Re: Proposed Delineation Work Plan – Battle Federal #4H
Marathon Oil Company
Unit Letter “M”, Section 27, Township 21 South, Range 33 East
Terracon Project No. AR177179

NMOCD approves of the proposed delineation for 1RP-4760 with these conditions:

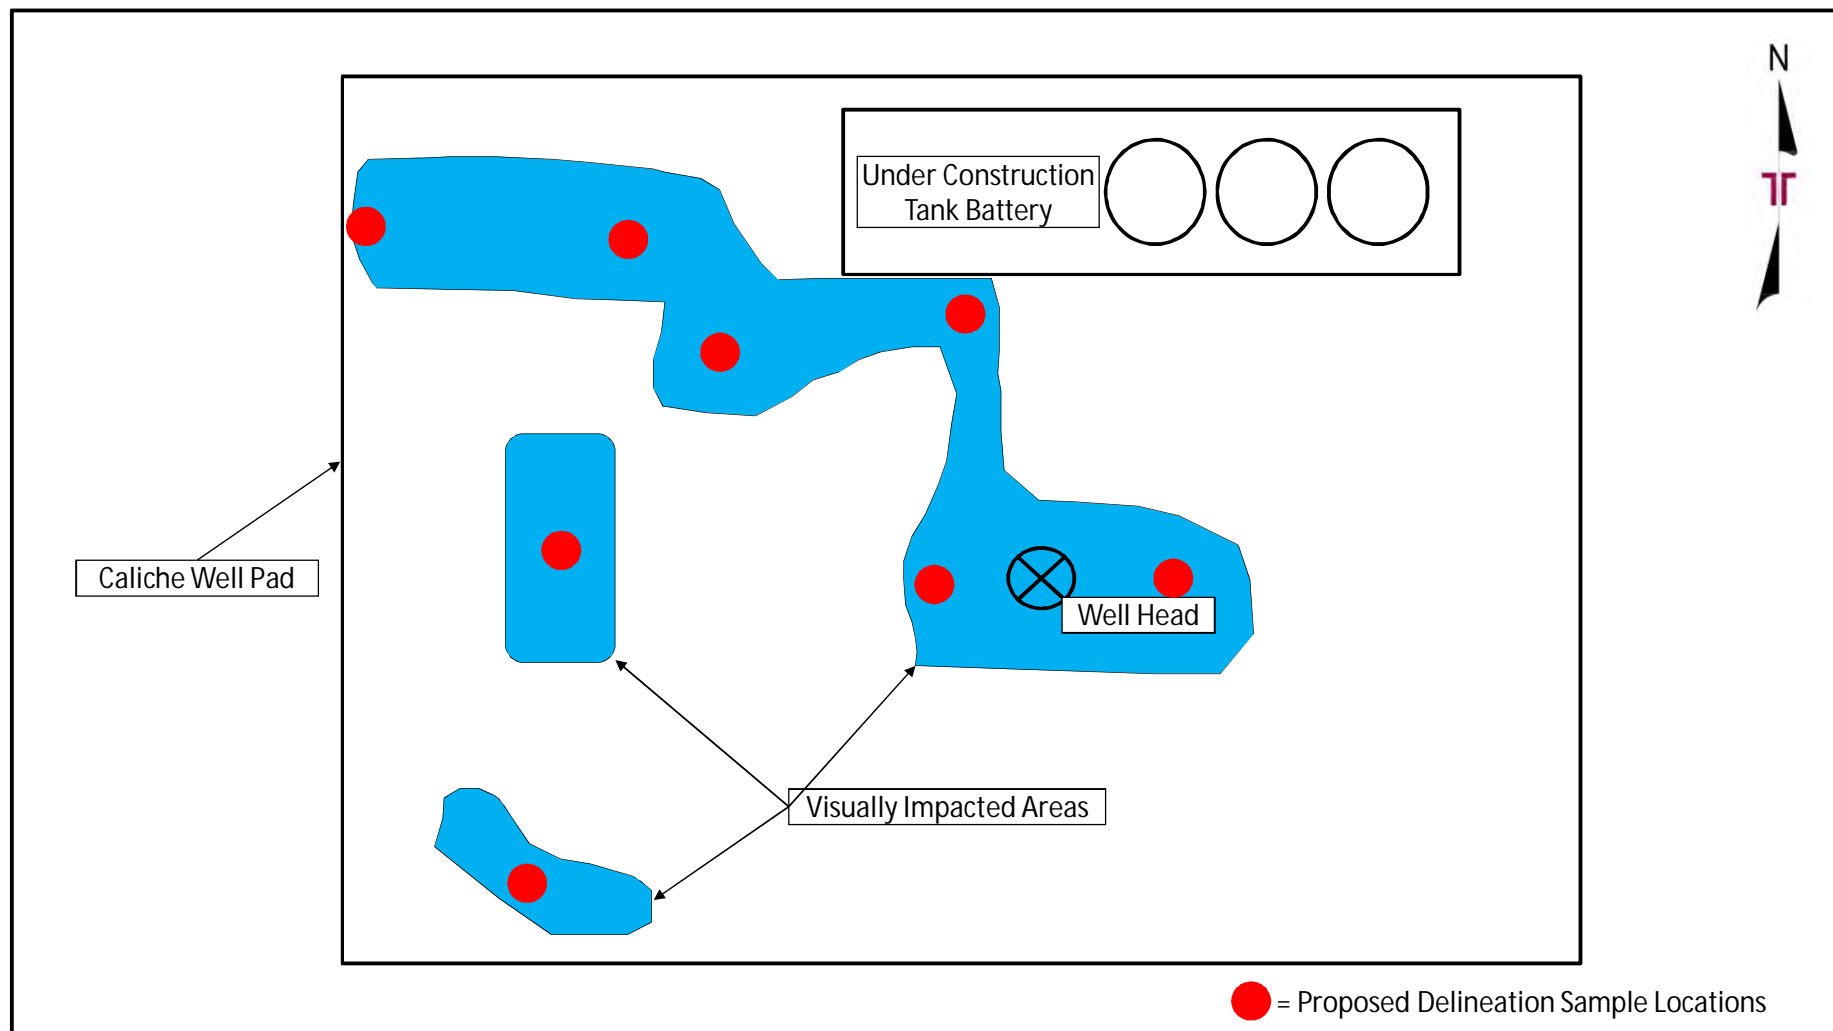
Permissible chloride levels are ≤ 600 mg/kg for horizontal and vertical delineation. Laboratory analyses are required from each soil sample for two depths (depth obtained and depth maintained 5 ft. further) and from the edges of the release area. Provide all relevant field data.
